Amendment to Document WP.29-143-07
(based on ECE/TRANS/WP.29/2007/100 Add 1)
(Agenda item 4.2.7 – Regulation No. 13)

The comparison of accident cause between Germany and Japan for vehicles of the classes N2, N3, and M3

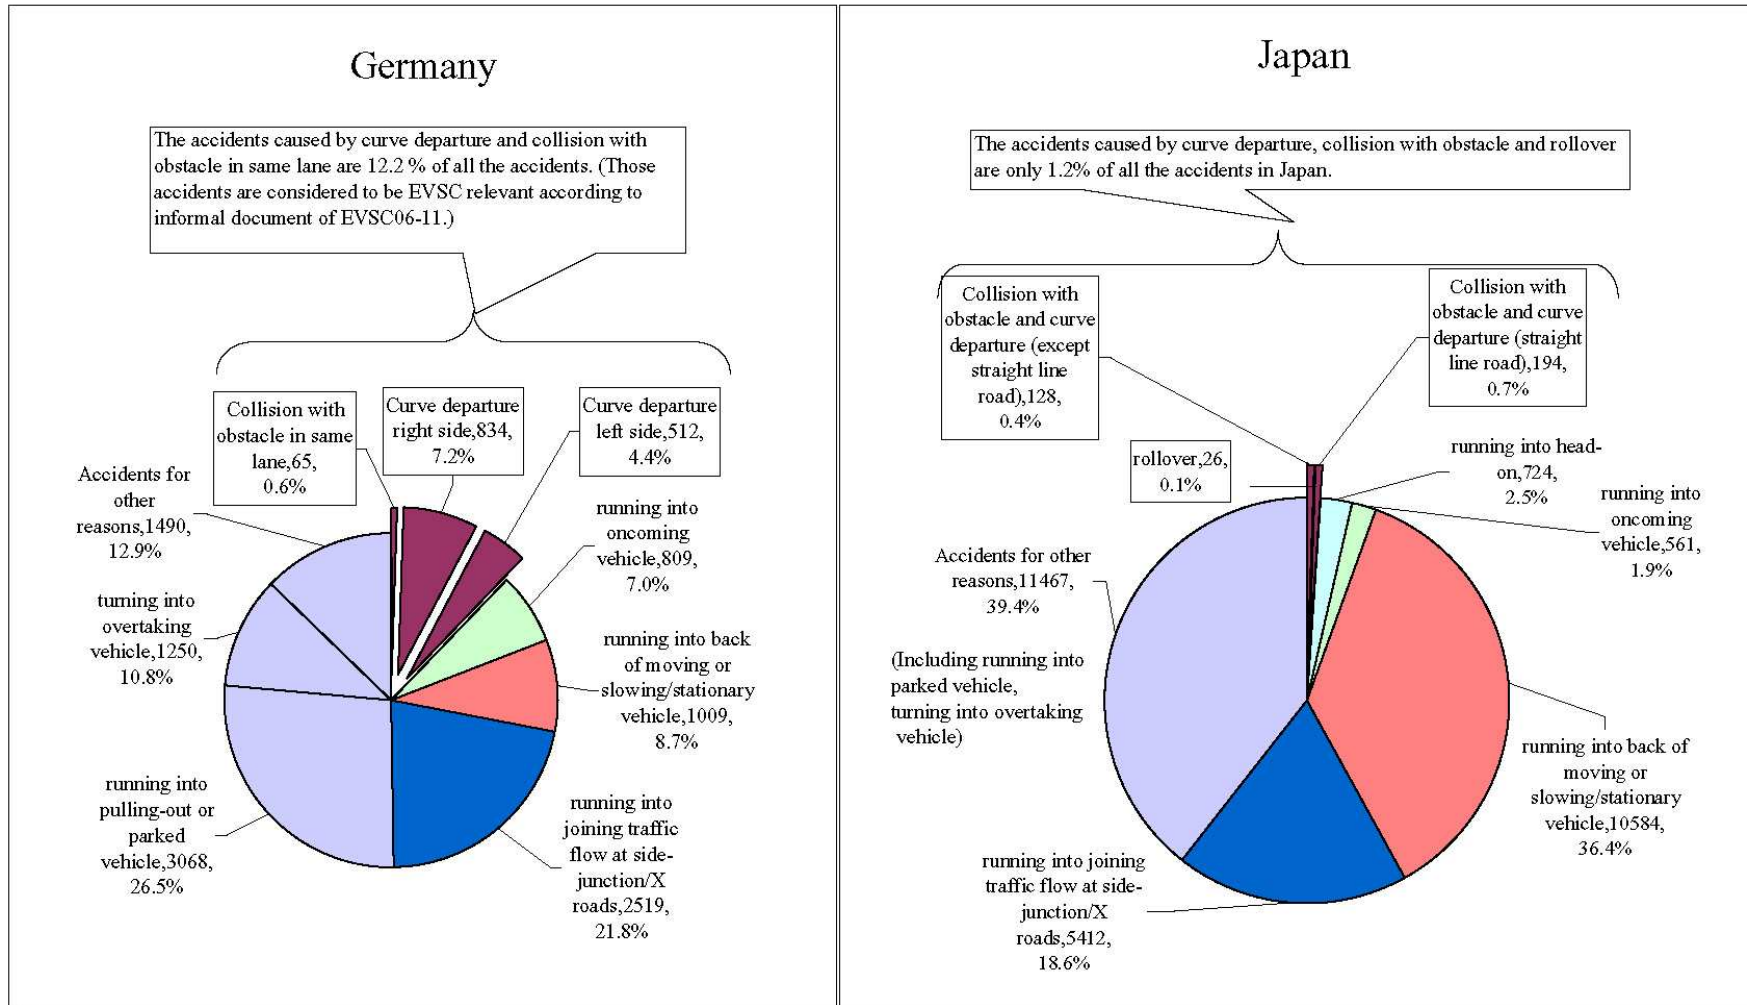
Analysis result of accidents in Germany and Japan is attached for reference.
